**Proposed Temporary Warehouse
(Excluding Dangerous Goods Godown)
For a Period of 3 Years in “Residential (Group D)” Zone,
Lot Nos. 146 S.B. ss.1, 149, 150 (Part), 151, 152(Part) and 153
in D.D.128, Ha Tsuen, Yuen Long, New Territories, Section 16A
Application No. A/YL-HTF/1137-2**

**Drainage Impact Assessment on
Proposed Surface Drainage Outflow
(Rev. B)**

Responses to DSD's Comments Dated 4.10.2023

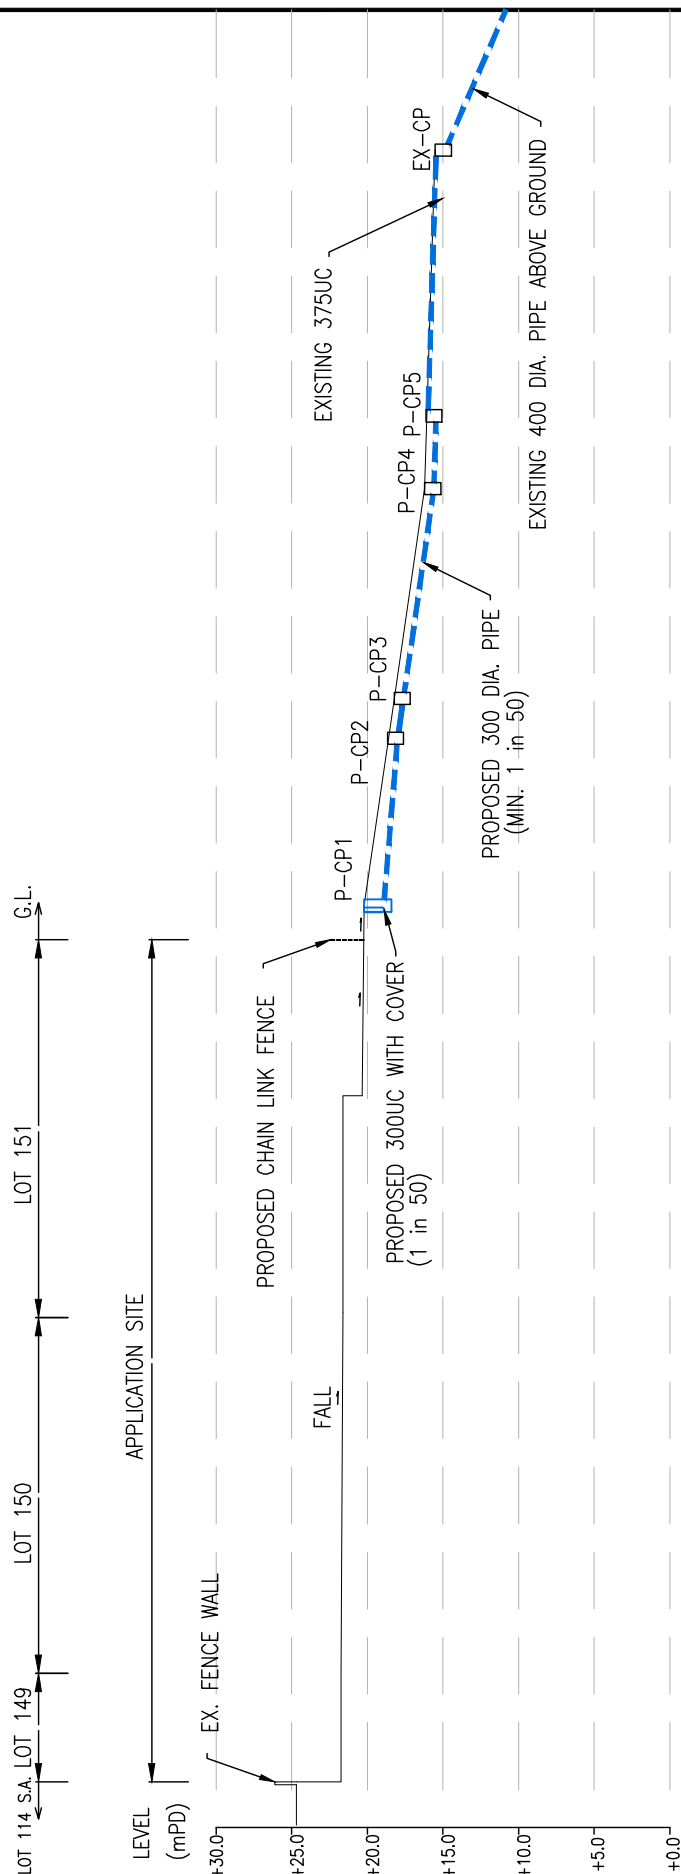
(iii) Appendix A: As stipulated in Section 11.10 of the Stormwater Drainage Manual published by the Drainage Services Department, backdrop manholes should be used at catchpit P-CPT16 where the level difference between the proposed connection invert level and outlet invert level is greater than 600mm.	Noted. The invert level difference is reduced to less than 600mm.

Site Layout Plan

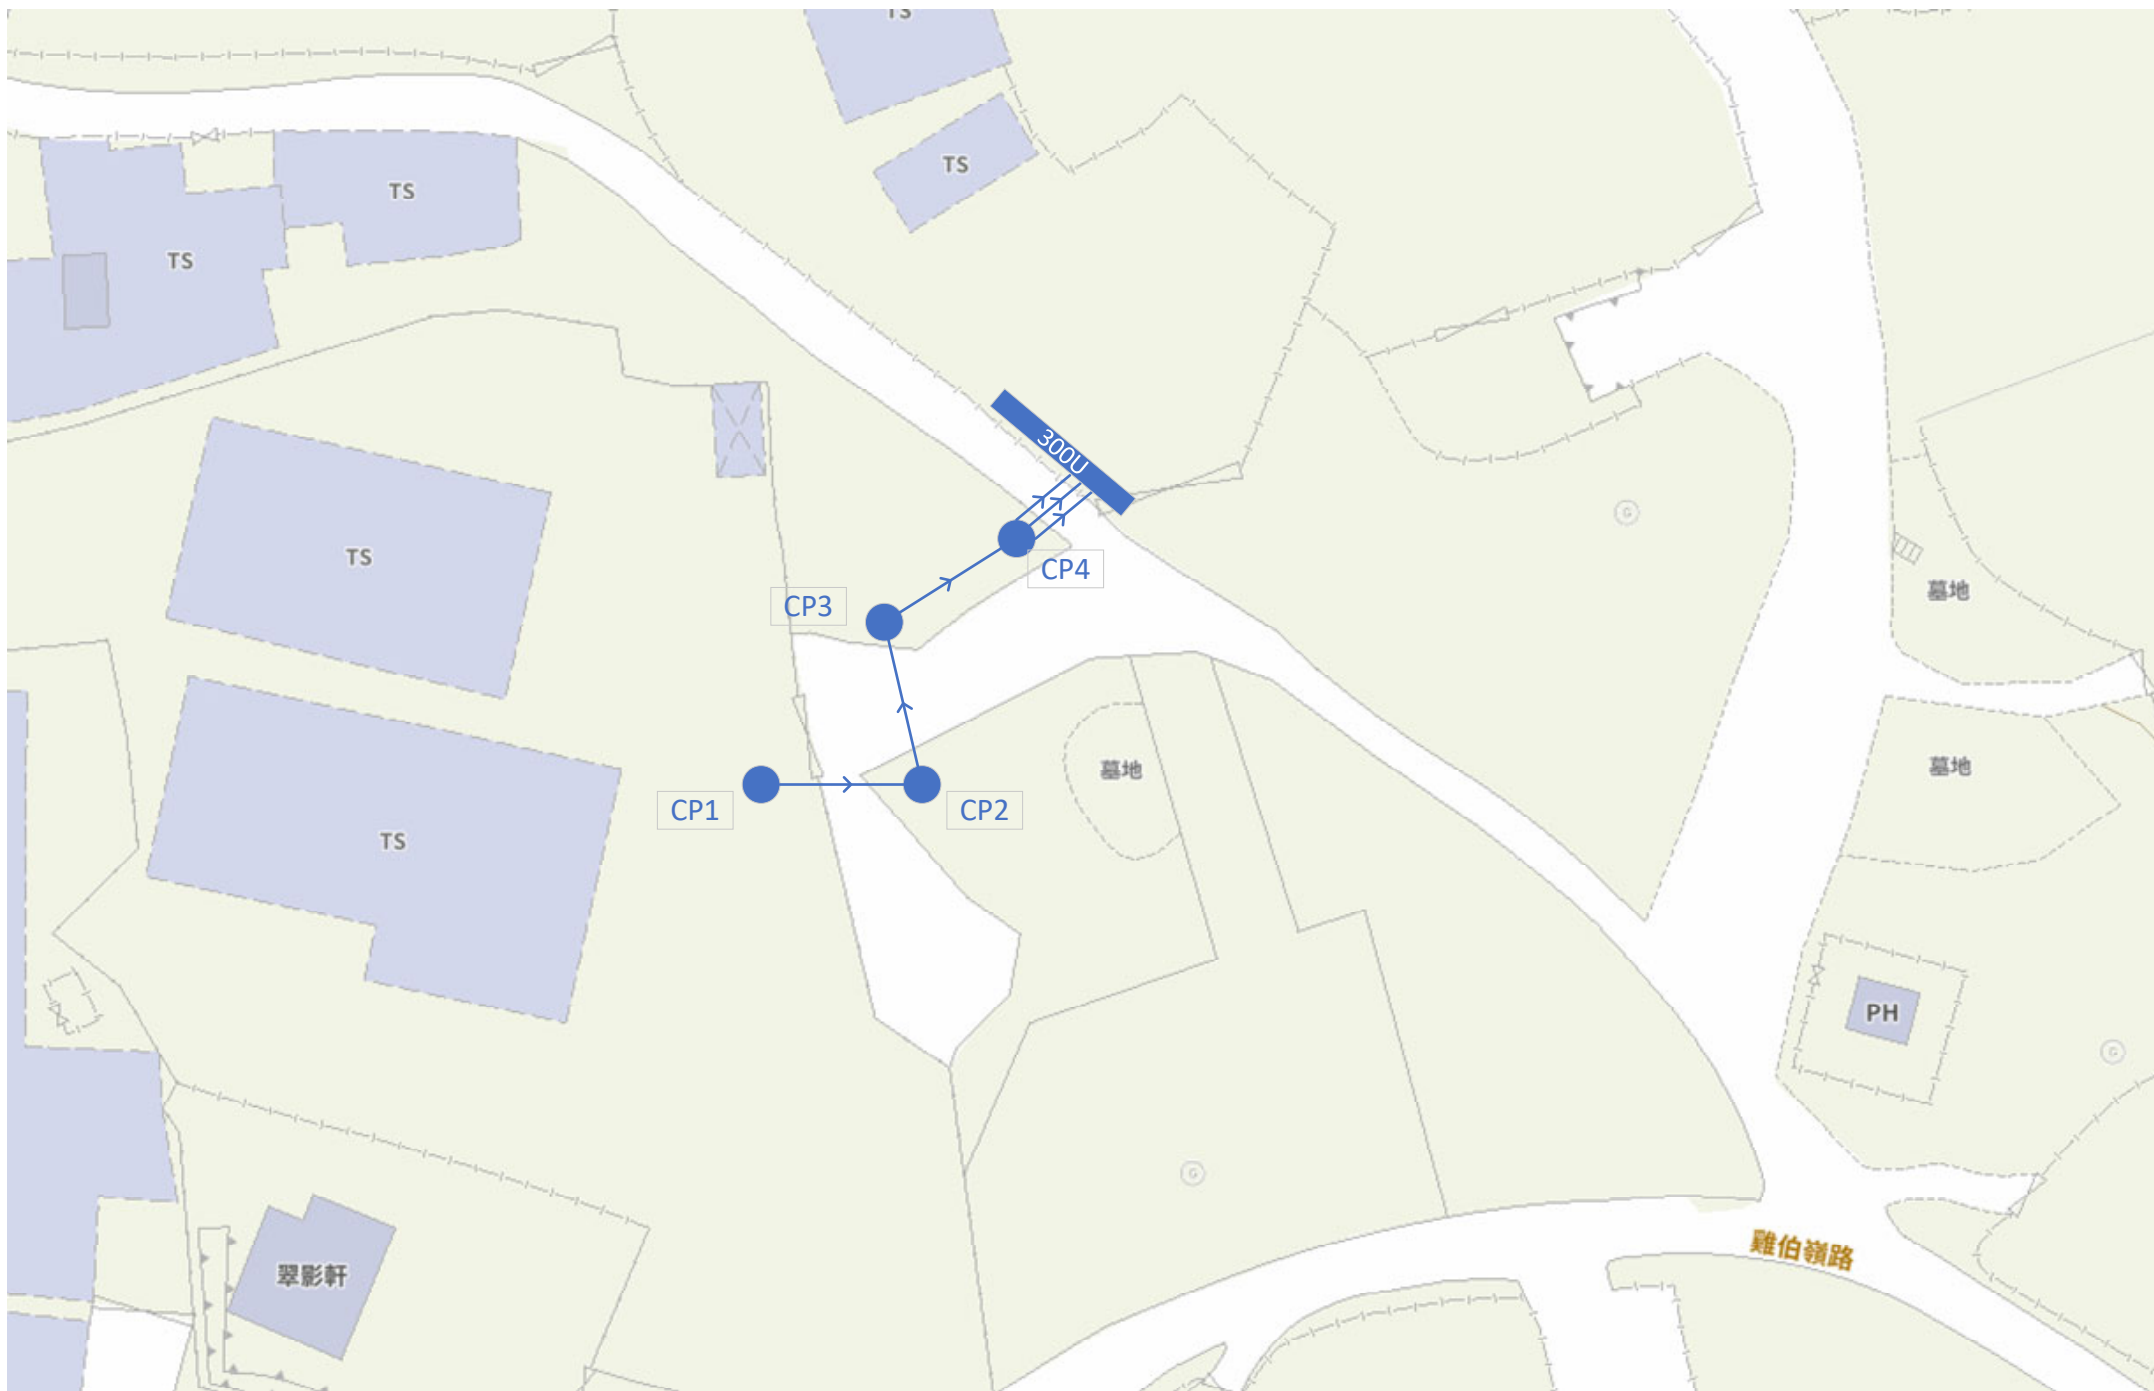
(iv) Appendix D: According to item (i) of the R-to-C, please clarify whether the rigid fence wall are within the boundary of application site. Please note that items (x) to (xii) of our previous comments dated 2.12.2022(and stated in letter to you dated 5.12.2022) are still valid. Adequate opening should be provided at the existing fence wall within the application site to intercept the existing overland flow passing through the site. As such, external catchment shall be considered in the calculation.	Noted. The addition catchment E (external catchment) from the upper lot is added to the calculation. The proposed surface channel is changed to 375UC from 300UC accordingly.
